ZENG'S UW APARTMENTS

4715 & 4719 21ST AVE NE
SDCI Project # 3039543-EG
3039616-LU

DESIGN RECOMMENDATION PACKET

LED Light Frame

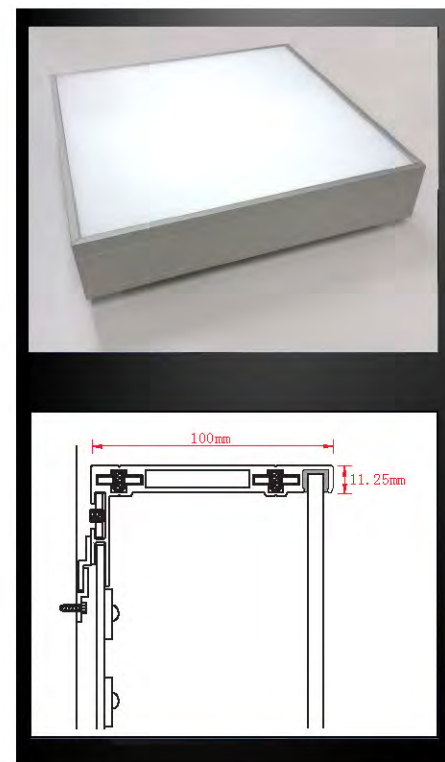
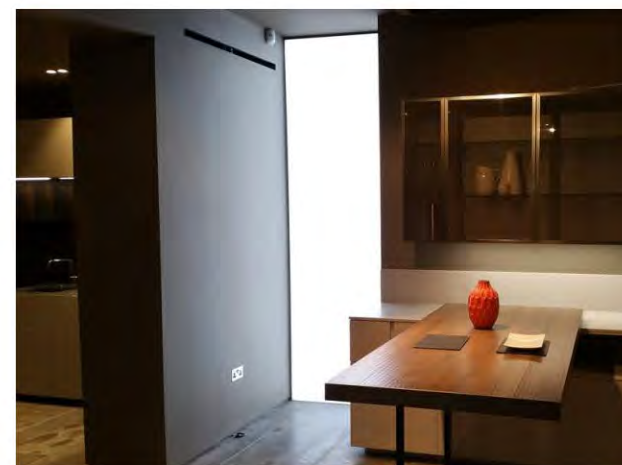
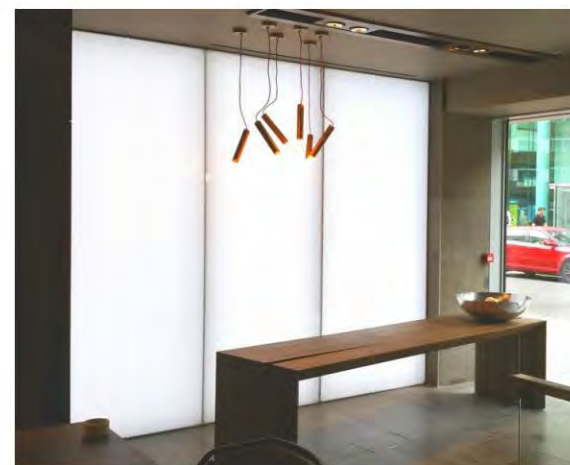
The guideline response within this packet describes the entry as a "lighting box." Please include a lighting plan in the Recommendation packet to show how site/building lighting will help to achieve this intent.

1. We propose to add LED light frame around where the lighting box meets the main building, which helps to enhance the idea of "lighting box inserting into the big massing", especially when it is lit up by lighting during nights. Please see attached for Specifications of LED light frame.
2. A metal canopy has been added in the middle of the glass box, which would provide weather protection for the pedestrians; building address signs have been added on the center of the lighting box, which will help in way-finding.
3. Letter "W" has been Integrated in the pavement in front of the lobby, which will create a sense of place for this special location.

MASSING ANALYSIS

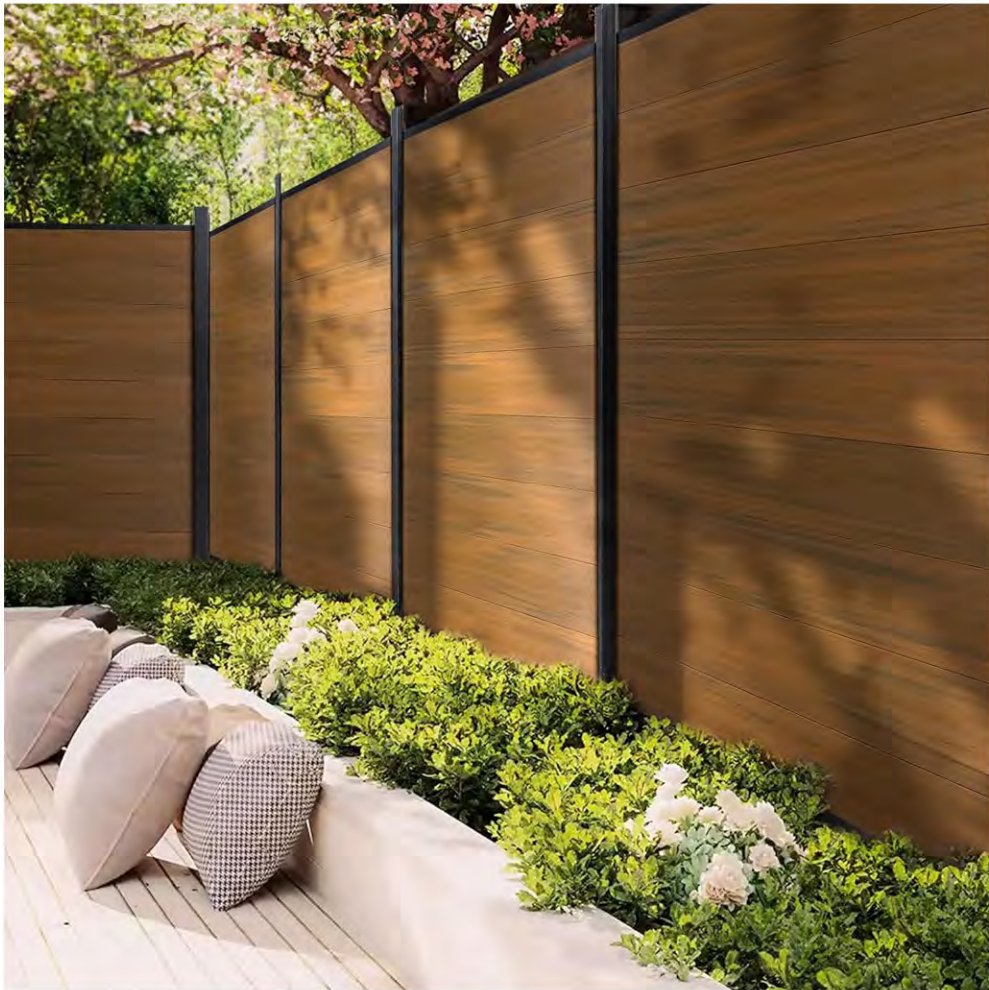
Addressing the adjacent development to the south using massing. All three design options appear to have similar massing relationships to the fraternity building to the south. All three have relatively tall vertical walls next to it with vertically-oriented massing elements. Although the preferred Option 3 shows a change of material on the building’s lower level in an attempt to relate to the shorter height of the fraternity, the material change appears superficial and doesn’t have a strong relationship to the adjacent shorter development. Because of this superficiality, the preferred option isn’t much different from the other two options. My suggestion is that you use the three design options to examine stronger, more legible ways of relating to the fraternity building. Option 3 uses a deeper front yard setback. You may use Options 1 and 2 to examine other possibilities like upper-level massing shifts or an arrangement of massing elements that gives the project design a stronger horizontal orientation. The vertical massing forms in all of the options seem to work against attempts to relate to the shorter horizontal massing orientation of the adjacent building. Here are some design guidelines that you should consider as you refine the massing related to the fraternity building:

The proposed design does not appear to address comment 1b from the EDG report. The building design appears to minimally respond to the shorter height of the adjacent fraternity building to the south. A legible top-floor massing shift away from the south lot line seems to be the most straightforward way to address guidance. The current proposal for a change in material at the top floor does little to visually reduce the bulk of the building. Please address comment 1b in the project design. If you still intend to proceed without a top-floor massing shift, you should study the use of a more dramatic change in materials, such as the addition of significantly more glazing at the top floor and the reduction of the parapet height.

We propose to setback the bottom and top floor along with material change on south facade. For the upper floor, we would setback the middle section further more to reduce the massing. The setback area would be private amenity for the top floor units.

PAVEMENT OPTIONS REFERENCE PICTURES

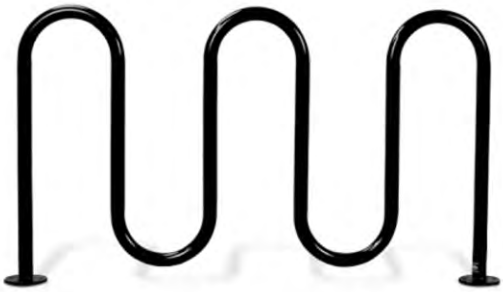
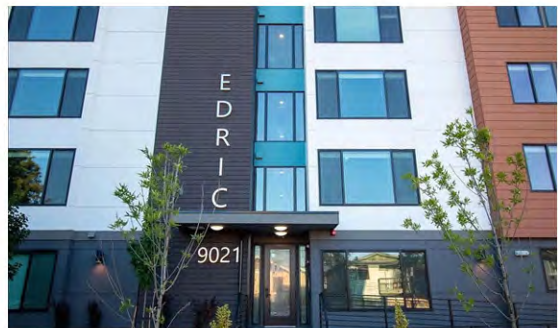
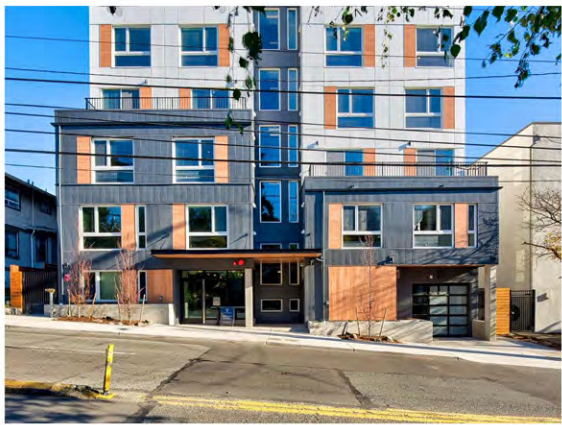
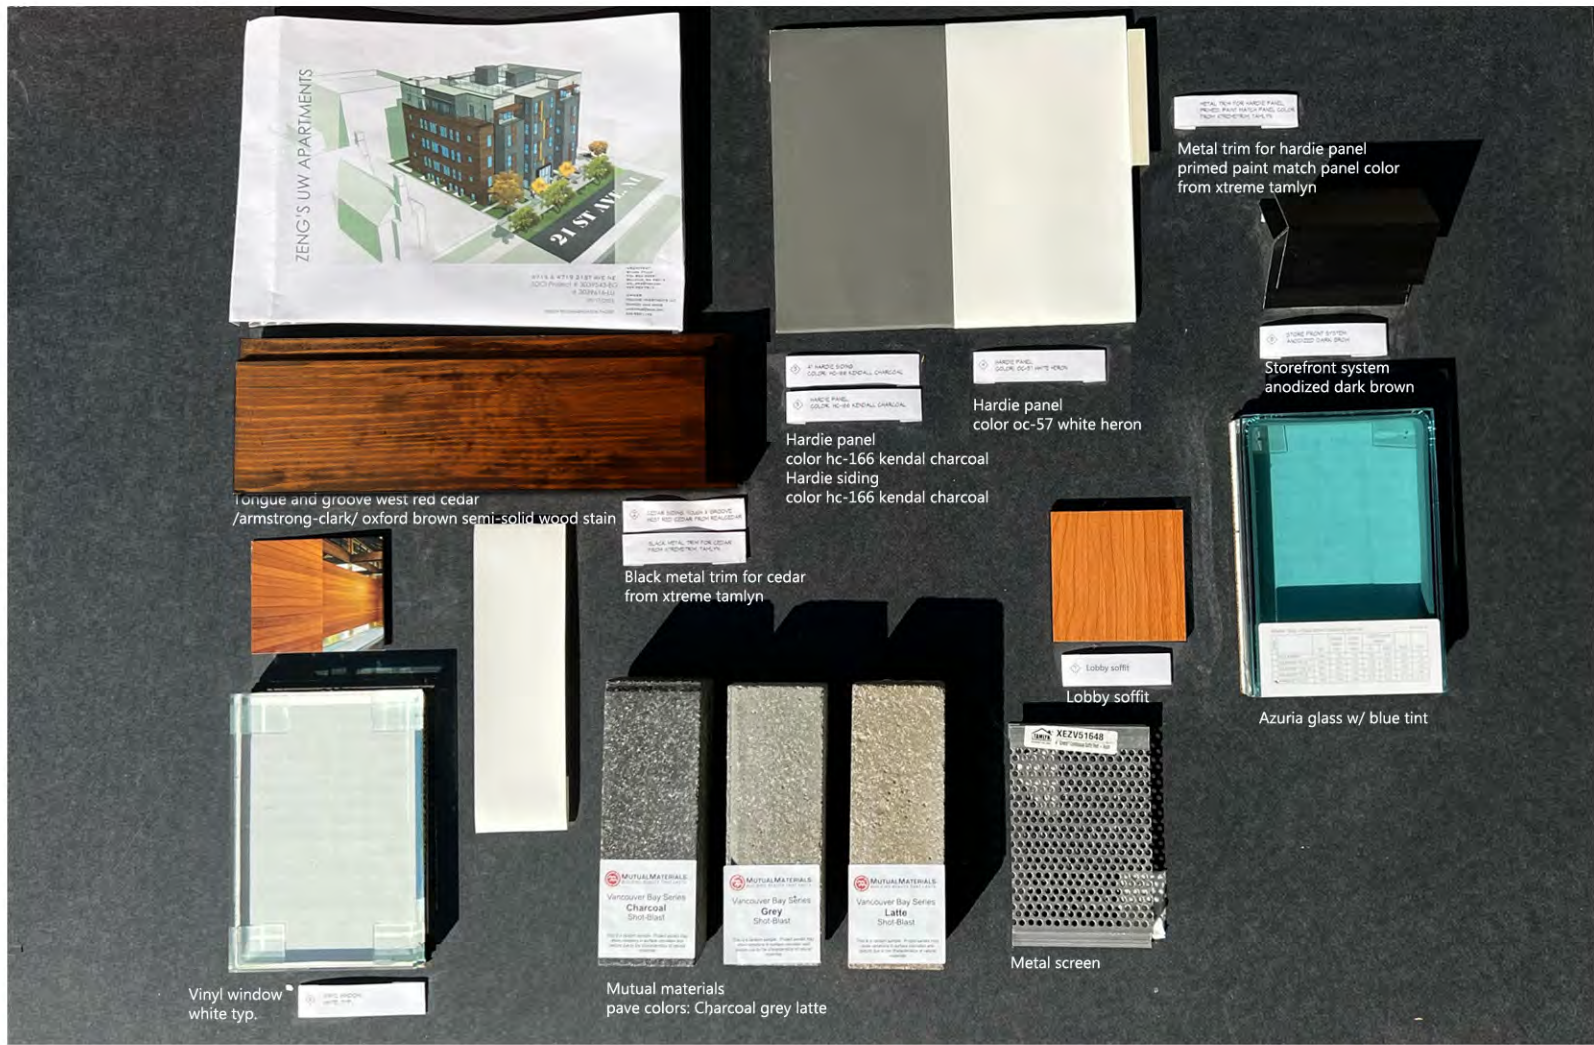
Repeat Comment: The design of the paved space within the front setback does not sufficiently address EDG comment 2b, which discusses the need for shared amenity spaces along the street frontage to serve as organizing elements within the development that act as a “front porch” for residents, and support community interaction. Although the southern space appears to have a strengthened connection to the primary entry, both the northern and southern spaces lack design elements such as organized seating or other spaces that would promote community interaction and promote activity along the street frontage. Strengthen design of the site frontage to address this EDG guidance.
PL2-A-1. Access for All, DC1-A-2. Gathering Places, University DC3-1-A: Open Space Organization & Site Layout, and University DC3-3: Street-level Open Space, DC3-B-4. Multi-Family Open Space.
Update for Recommendation packet: Staff still has concerns about the design of the front setback related to the initial MUP comment above. If you would like, we can set up a meeting to discuss this element.

1. We eliminated the two planters in front of the main lobby, and placed a chess plaza on the left and a ping-pong table on the right to embrace various activities.
2. We placed a bench and a circular seating south to the chess plaza area to gather people.
3. We relocated the other two planters against the building facade to soften the building edge and reduce the massing height, which also helps to enlarge the common front yard area. The northern planter is bigger in size, which also functions as a barrier between the solid waste area and main entrance.

Departure Name SMC 23.45.518. Rear Setbacks (Table A for 23.45.518).

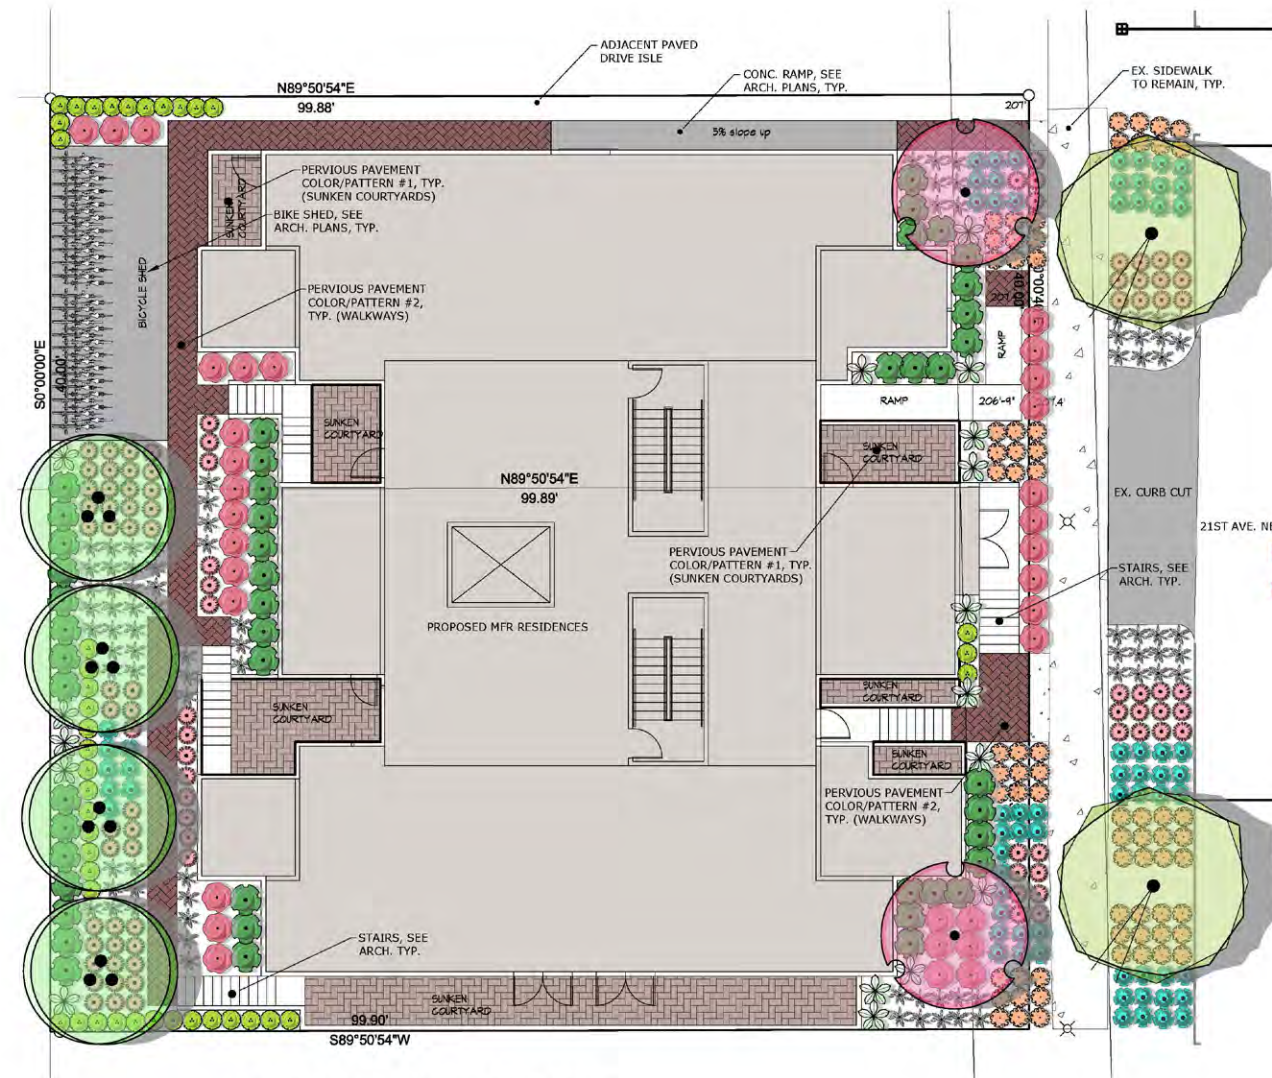
- a)The Code requires... (insert language)
- b)The applicant proposes... (insert language)
- c)This will help the project better meet the intent of Design Guideline... (insert guideline(s))
- d)By doing (describe how) and provide graphics, as needed, to clearly explain the departure(s) showing code compliant dimension/area and the requested departure with dimensions/sq. ft./percentage of difference.

- d) The required rear setback is 15', the proposed min. rear setback is 10', average rear setback is 17.88'. Amount of requested departure for rear setback is 5'.The required front setback is 5'.The propose min. front setback is 10'-10 ½", average front setback is 17.49. The design focuses the shifting massing volume from the street façade towards the rear. The enlarged front setback allows more landscape to soften the street edge, provide adequate buffer space as a transition from the sidewalk to residential use and physically & visually engages the public realm. Please see the below for the comparison between code compliance site plan and site plan with requested departure---the generous front yards could maximize active uses along street frontages.
